CITY OF MOLALLA WASTEWATER TREATMENT PLANT UPGRADES VALUE ENGINEERING REPORT DECEMBER 10TH, 2021

UPDATED FEBRUARY 11, 2022
WITH IMPLEMENTATION DATA

This value engineering (VE) report is presented to City of Molalla and the design team to support decision making at the pre-design phase for the Wastewater Treatment Plant Upgrades project.

PROPOSAL	S-1
COMPONENT: Building Systems	AUTHOR	DH

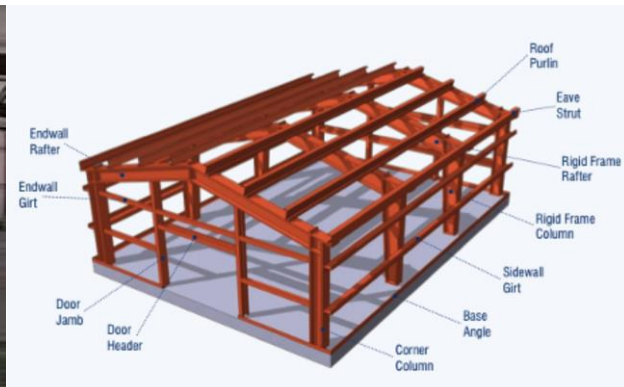
Auxiliary buildings supporting process structures and enclosing equipment are planned to be constructed using conventional wood construction with metal roofing and composite siding. These buildings include the SBR/Blower Building, UV Disinfectant Canopy, Aerobic Digester Building, and Biosolids Dewatering Building. Although conventional timber construction is relatively cost effective, it is field labor intensive, with resultant schedule impacts. In addition, timber construction is more susceptible to deterioration and moisture-sensitive than other types of construction.

The use of pre-engineered metal buildings (PEMB) for these facilities will provide metal construction that will be more resistant to moisture and resultant deterioration. PEMB construction also provides long clear spans and open space. Interior durability can be provided by wainscoting, and insulation can be done cost effectively. In addition, the cost of the a PEMB is typically less than wood construction, and as most of the components are fabricated in the factory, erection and field construction time is typically shorter than for conventional framed wood construction.

PROPOSAL	WI-1
COMPONENT: Grit Separation	AUTHOR	EF

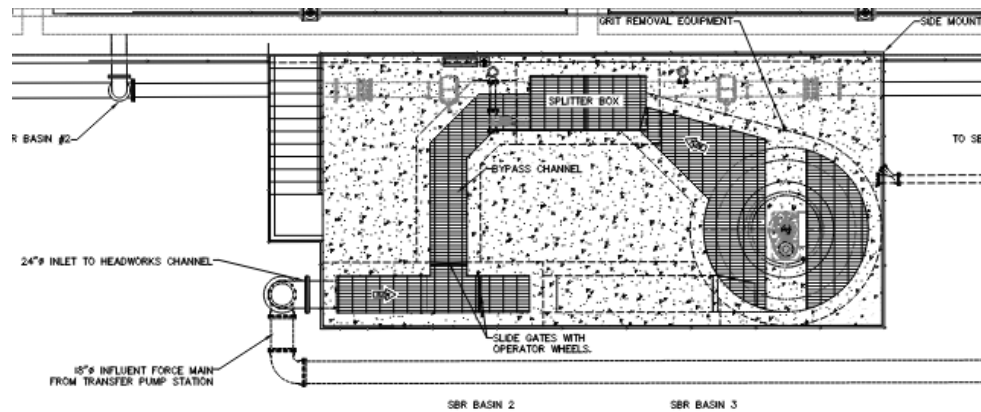
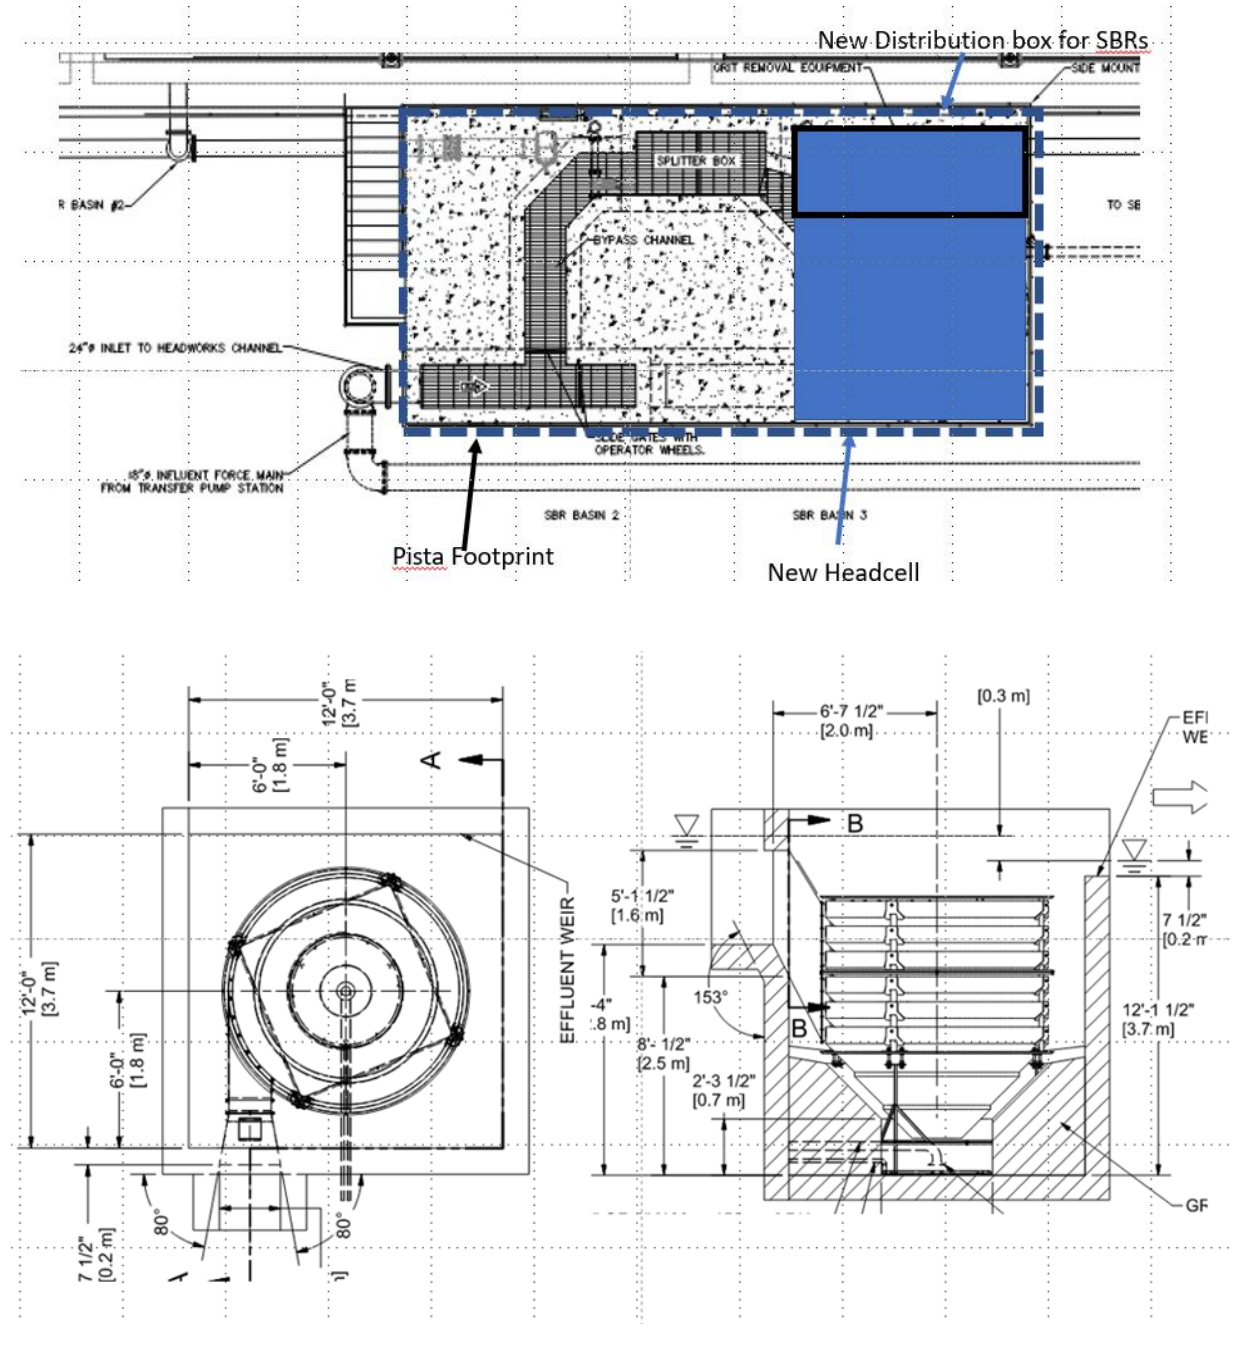
The system is shorter and fits well downstream of the transfer station and before equalization. The Headcell is proposed to get 104 micron grit at normal flows and 200 micron grit at the full 12 MGD peak flow.

A single 9 tray, 12' diameter Headcell looks as follows (12 MGD) when laid over the current design.

PROPOSAL	WI-2
COMPONENT: Influent Equalization	AUTHOR	EF

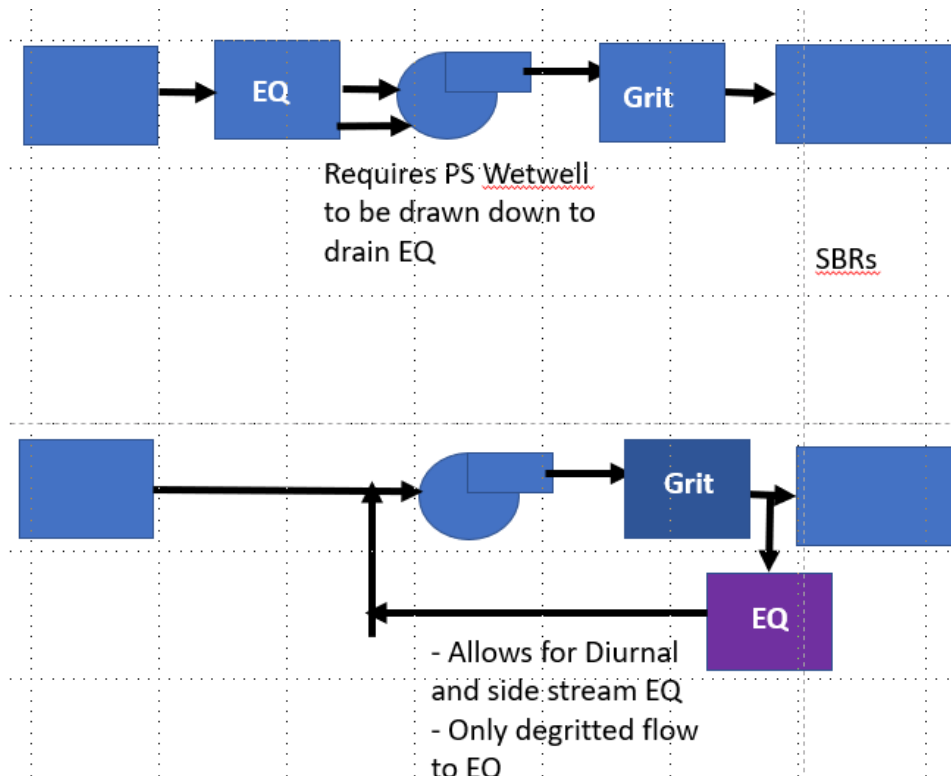
<p>DISCUSSION</p> <p>The current plan is to only use flow equalization during large wet weather events. Flows from the headworks over 9 MGD up to 12 MGD would be routed to an inground 1-million-gallon tank.</p>

The proposed moves the EQ to after grit removal. The full 12 MGD peak flow would get grit removal and then 3 MGD would be split off to EQ. The EQ basin could also be used for smoothing diurnal peaks and side stream equalization reducing the design loads on the SBR.

Current and VE concept flow diagrams are shown on the following figure.

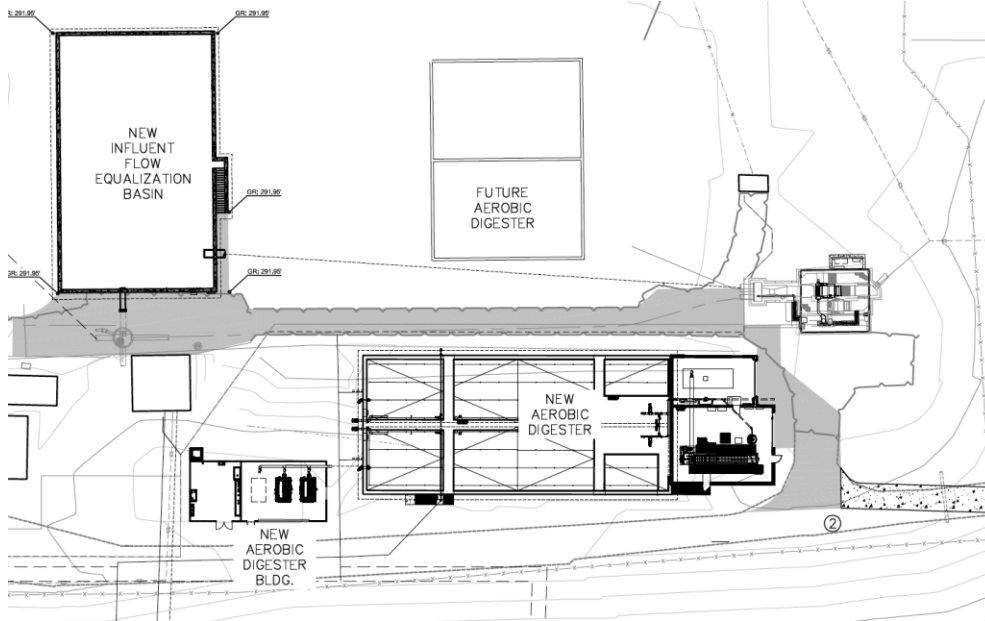
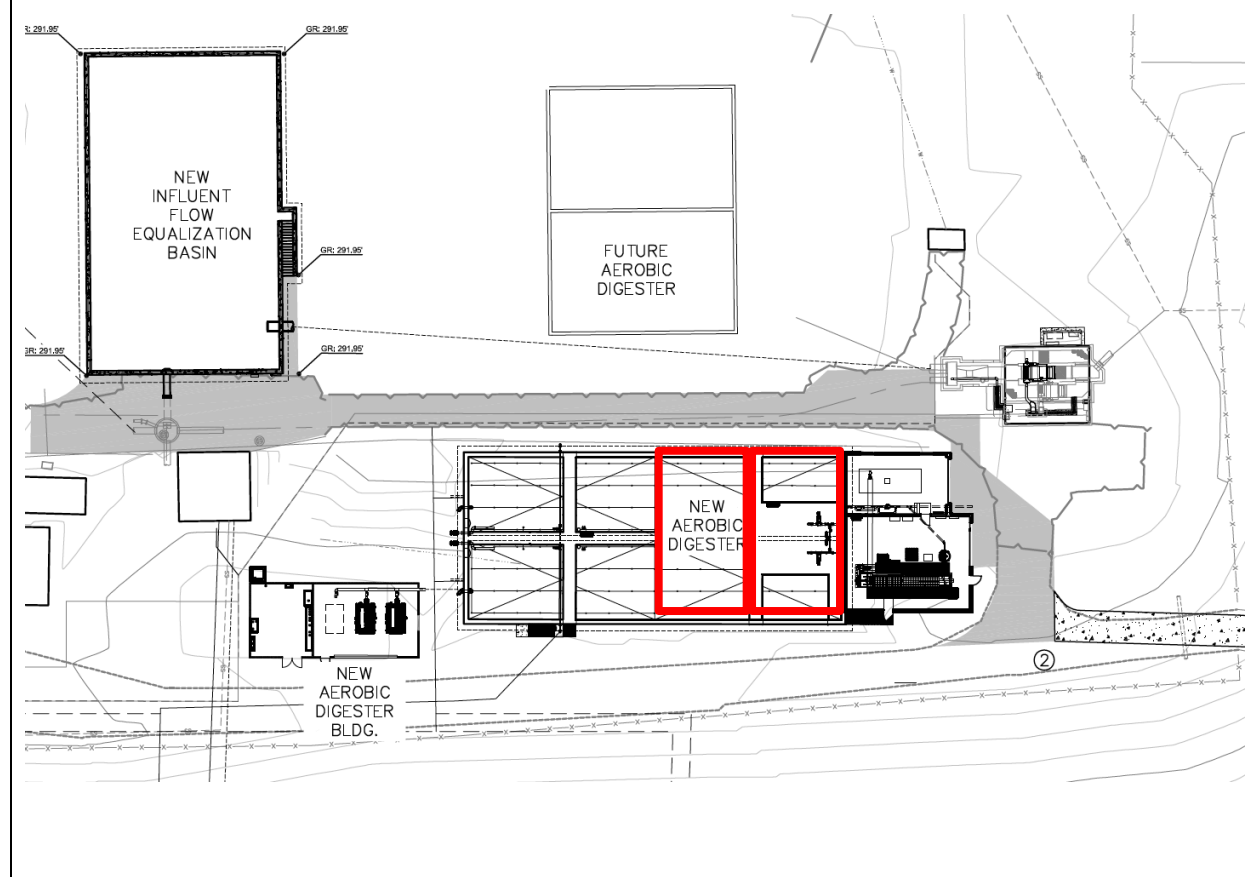
- Provide adequate tank volume to allow sixty days SRT for the projected sludge loading for the year 2035 (Phase I).
- Minimum 38 percent vector attraction reduction.
- Provide an overflow between basins.
- Provide the ability to sequentially fill digester tanks or fill each digester tank directly from WAS pumps.
- Provide adequate air distribution to accomplish mixing and aerobic digestion to produce a stabilized biosolids within the design residence time.
- Provide the ability to decant supernatant after settling from any digester basin. Target solids concentration within digesters of 1.4 to 2 percent.
- Provide a staff gauge for each basin.
- Have the ability to transfer sludge to any of the digester basins, Biosolids Dewatering Facility, or tanker truck loading.
- Provide Dissolved Oxygen / Oxidation Reduction Potential (DO/ORP) probe for process optimization and control.

The VE concept is to only construct 50% of the aerobic digester volume reducing the SRT in the aerobic digesters from 60 days to 30 days. The SBR tankage will then be reduced from two 400,000-gallon tanks to two 200,000-gallon tanks. Each tank will still have its own decant capability. With this concept, dewatered can only be hauled to the landfill for disposal. No application on local farmland will be allowed.

PROPOSAL	WE-1
COMPONENT: Effluent Filtration	AUTHOR	DCS

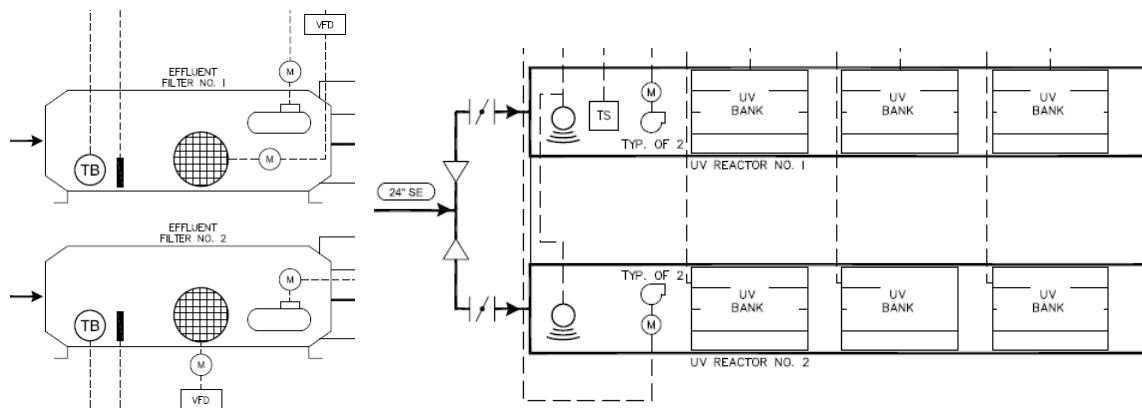
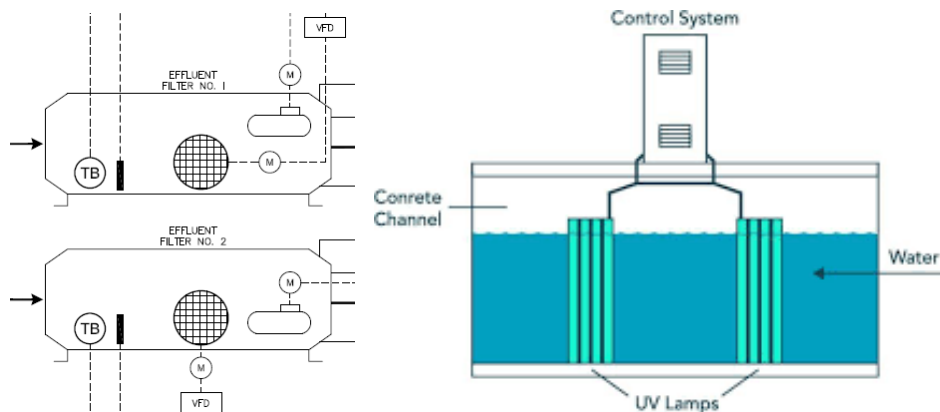
<p>DISCUSSION</p> <p>Reportedly, the effluent filtration is provided to: 1) Support future Class A reclaim water, and especially in Phase 1, 2) Allow use of highly proprietary UV treatment equipment.</p> <p>This proposal suggests two alternates to reduce the cost, complexity, and operations and maintenance cost of the filtration unit process by: A) Relaxing the degree of filtration from effluent Class A to Class C, as Class A is not required by the permit, or B) Eliminate filtration entirely and use non-proprietary downstream UV treatment equipment.</p>
--

Class A effluent filters (left) feeding proprietary UV treatment (right).

Class C effluent filters (left) feeding non-proprietary UV treatment (right) under Alt A, or no UV at all under Alt B.

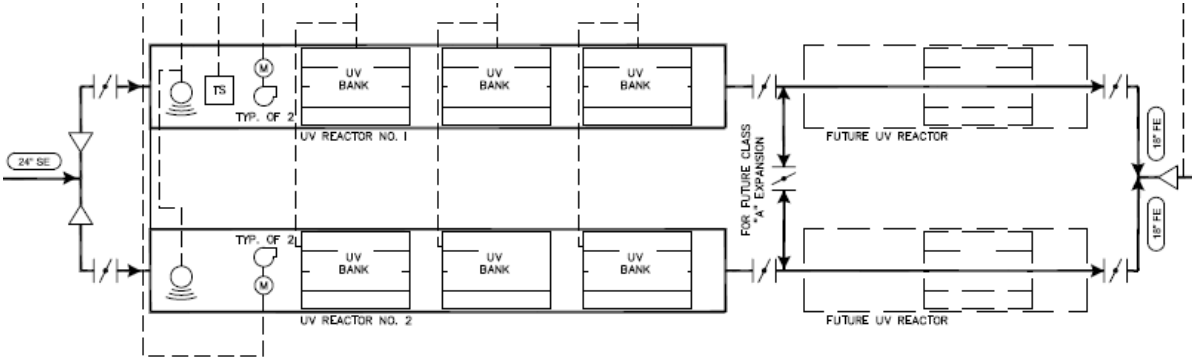
The need for future Class A reclaim water production is unclear and the project is overbudget. This proposal suggests eliminating Phase 1 provisions for the future upgrade to Class A treatment to reduce project cost and complexity.

UV disinfection to Class C with provision for future disinfection to Class A.

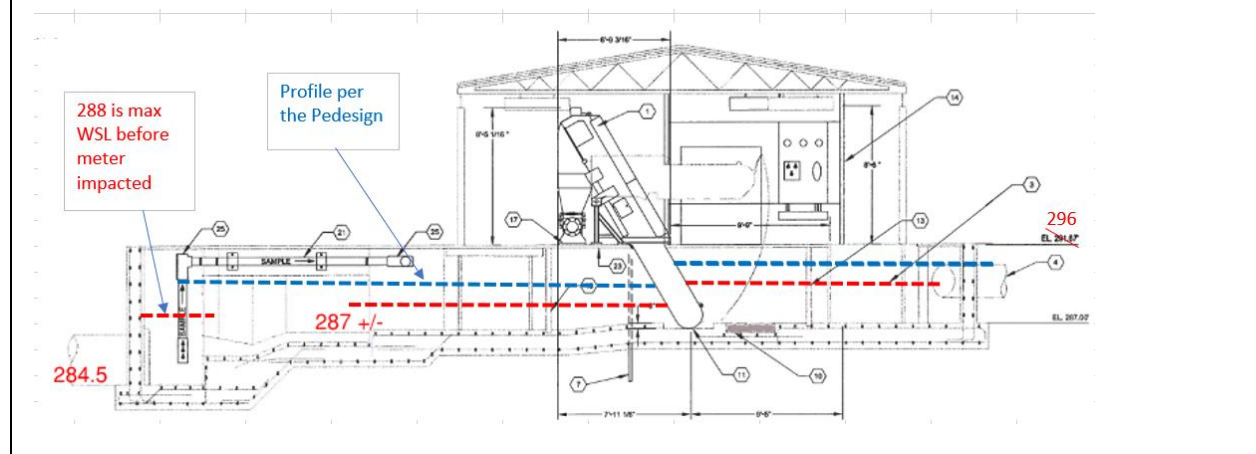
The hydraulic profile in the predesign documents shows a flooded Parshall flume as well as a surcharged influent sewer.

The hydraulic profile in the predesign documents shows a flooded Parshall flume as well as a surcharged influent sewer. It is unclear how this could occur, but pumping immediately after the headworks could eliminate this situation.
